May 31, 2016

Re: FirstLight Hydro Generating Company, Turners Falls Hydroelectric Project (FERC No. 1889) and Northfield Mountain Pumped Storage Project (FERC No. 2485).
Response to Stakeholder Requests for Study Modifications and/or New Studies Based on the Study Report and Meeting Summary

FirstLight
GDF SUEZ

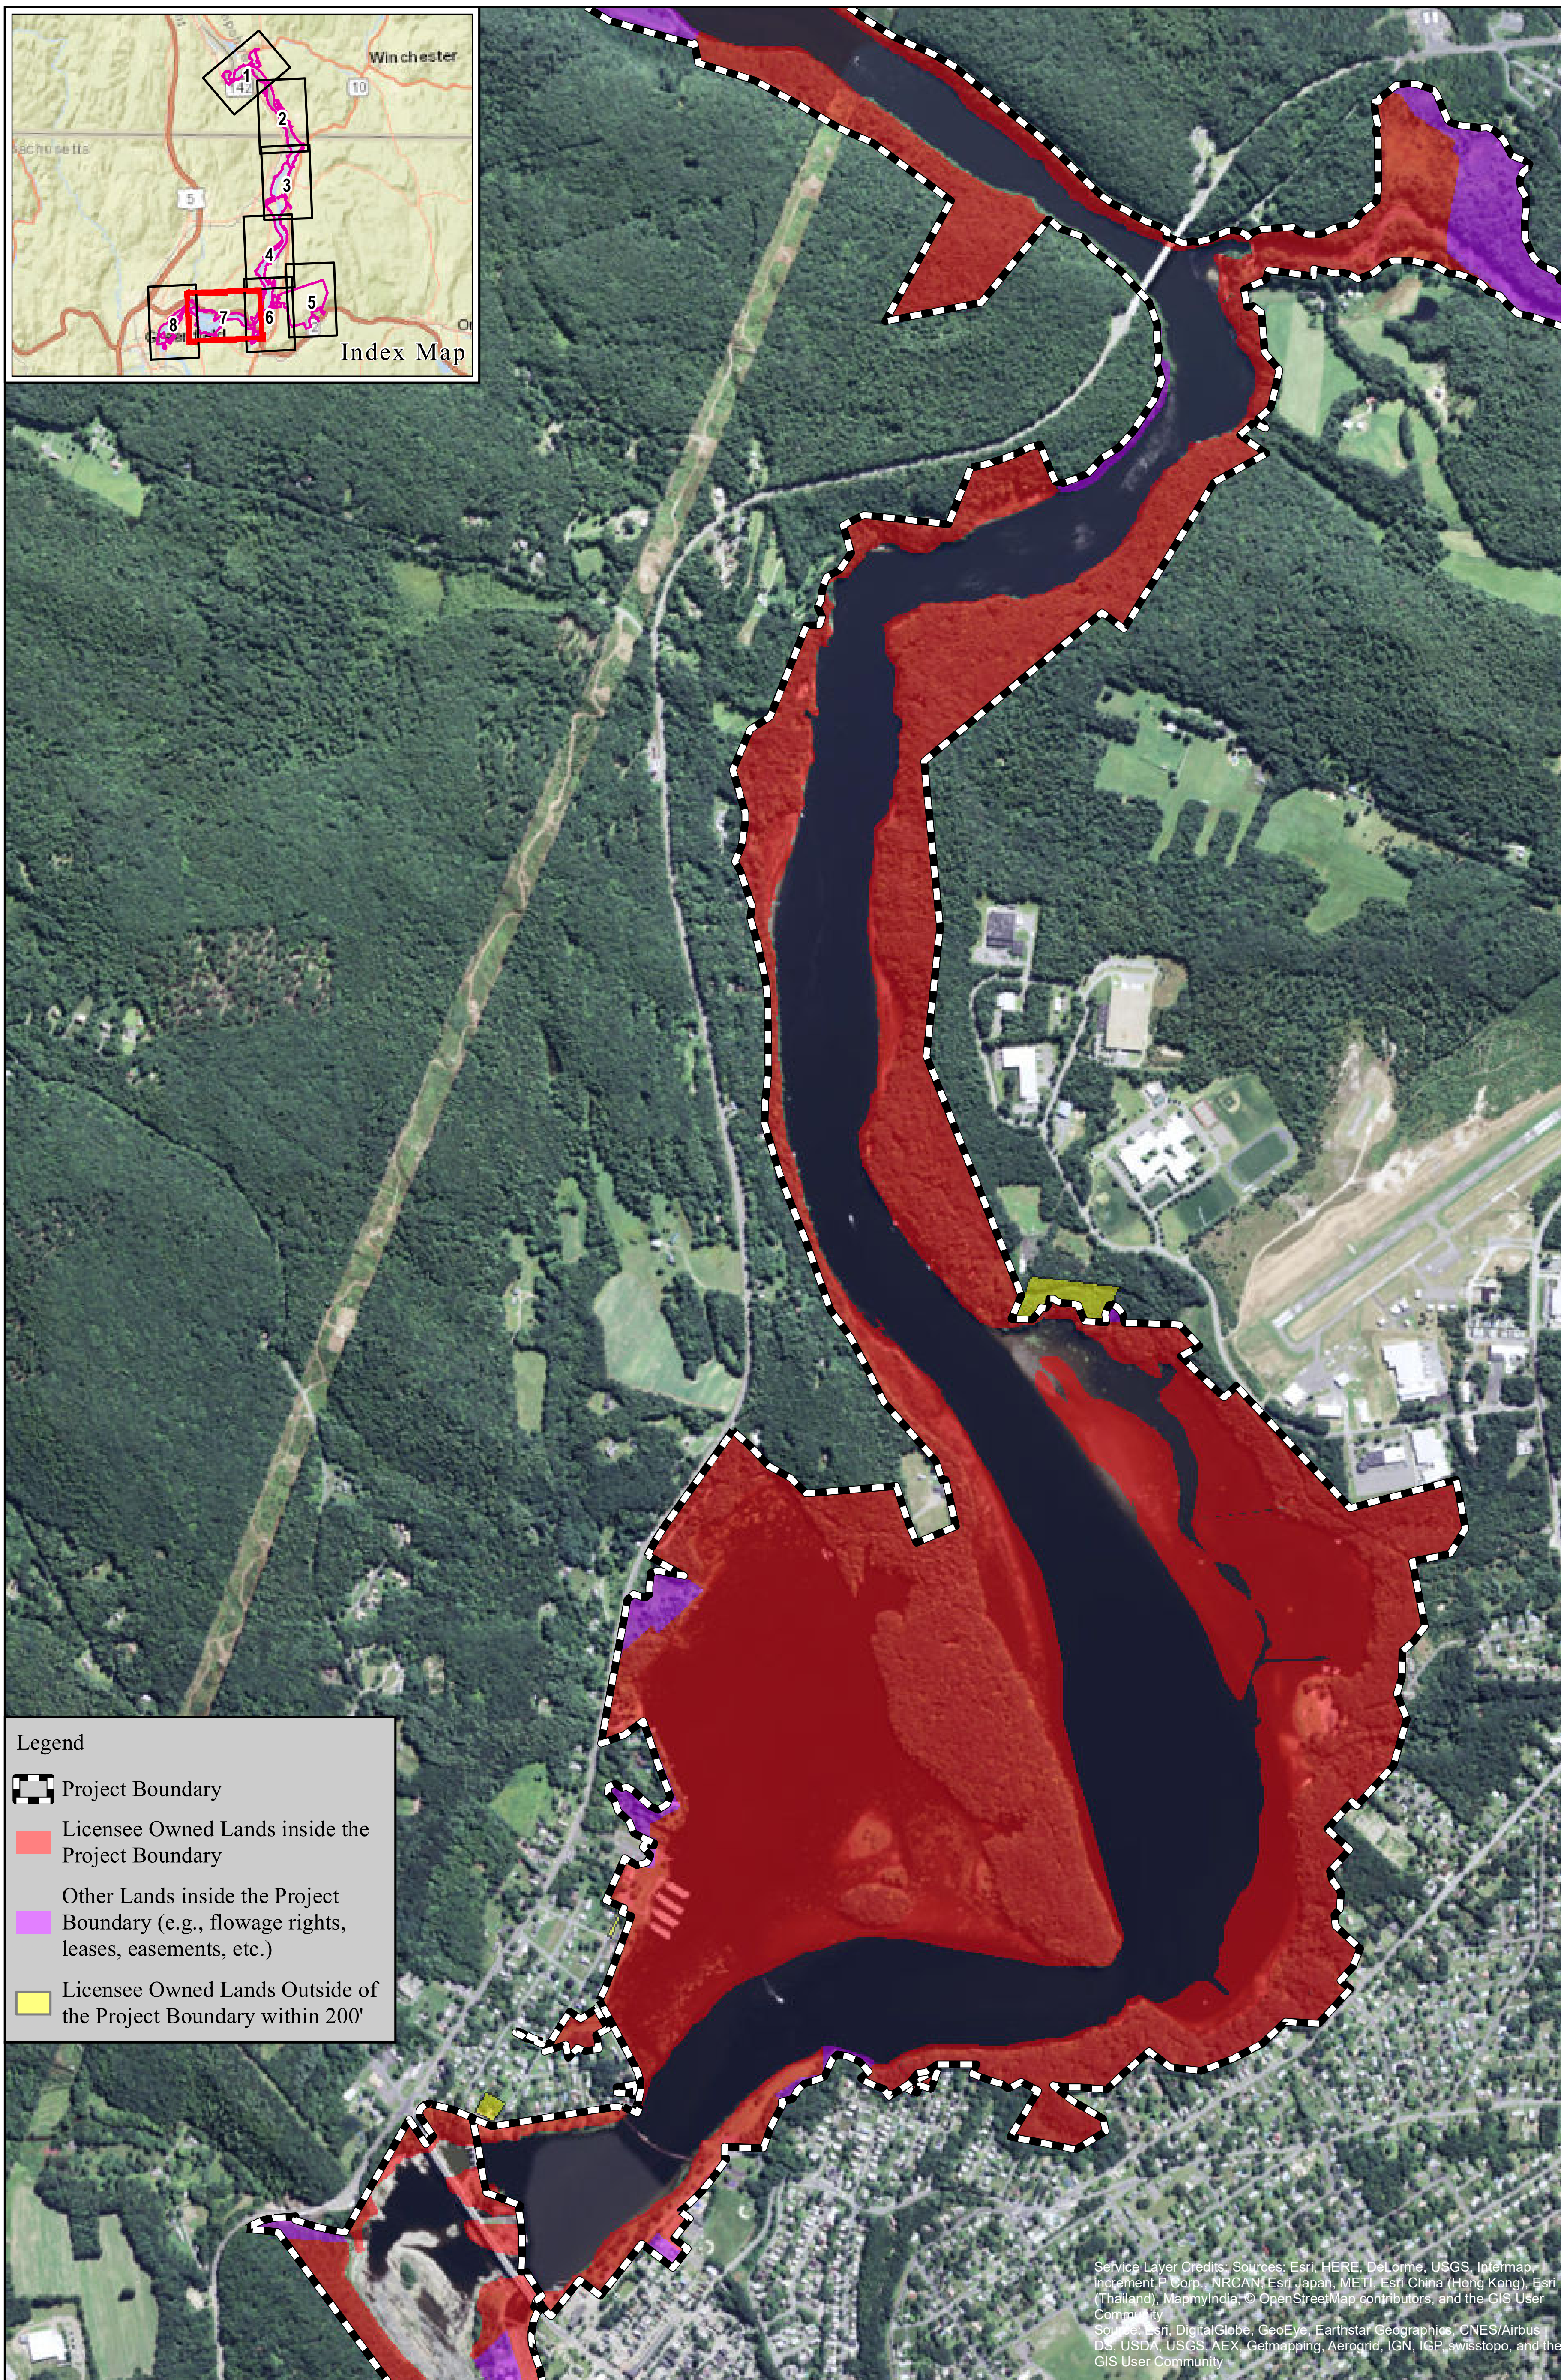
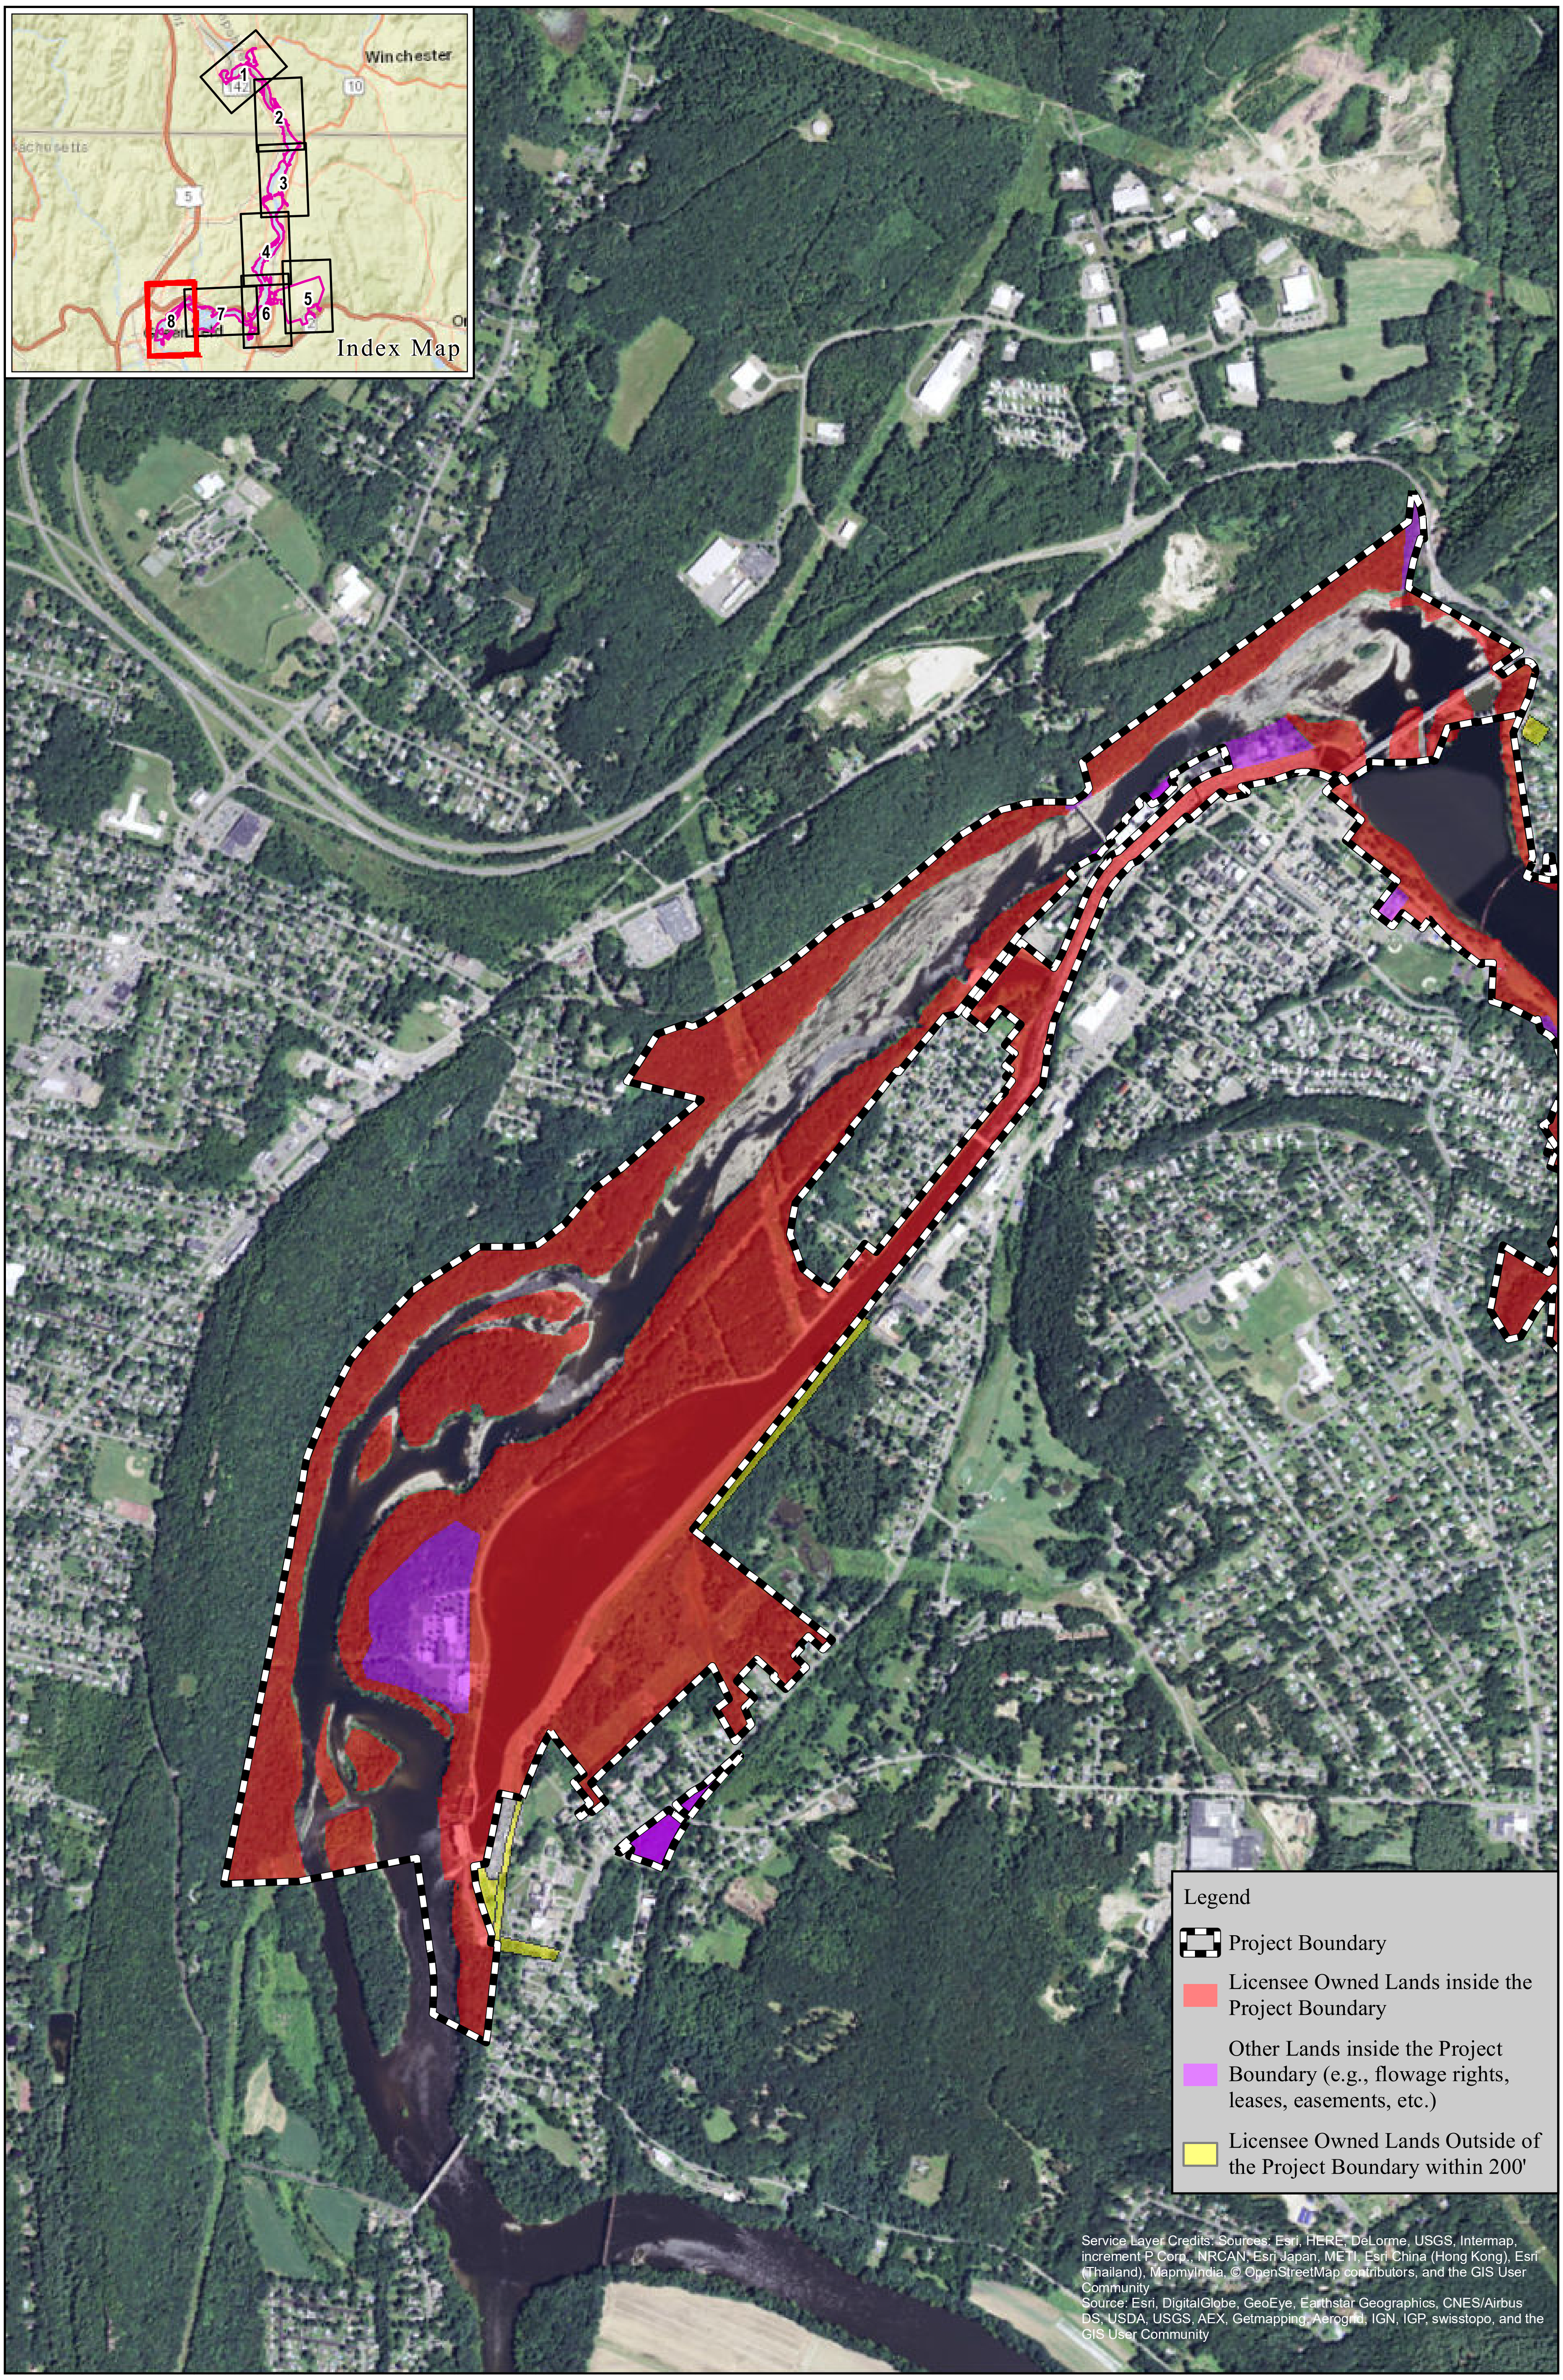
Commenter	Comment	Responses
CRWC-1	The report does not identify ownership and other controls such as FirstLight's flowage rights within the Project boundaries. FirstLight does not own all of the lands within the project boundaries. FirstLight ownership of lands within 200 feet of the Project boundaries is identified in Figure 4.4-1, but nothing indicates ownership within the boundaries. CRWC requests that FirstLight provide information on land it has ownership or any other control over, and the land use associated with those lands, in an addendum to Study 3.6.5.	FL has updated the maps that comprise Figure 4.4-1 in the 3.6.5 study report to show FL land ownership within the project boundary. See Study 3.6.5 Attachment A, Figure 4.4-1. The lands owned by FL shown are fee-ownership. The figures also show other lands within the Project boundary (e.g., flowage rights, easements, leases, etc.). The land uses associated with all lands within the Project boundary are provided in the 3.6.5 study report. An addendum to the 3.6.5 study report is not necessary.
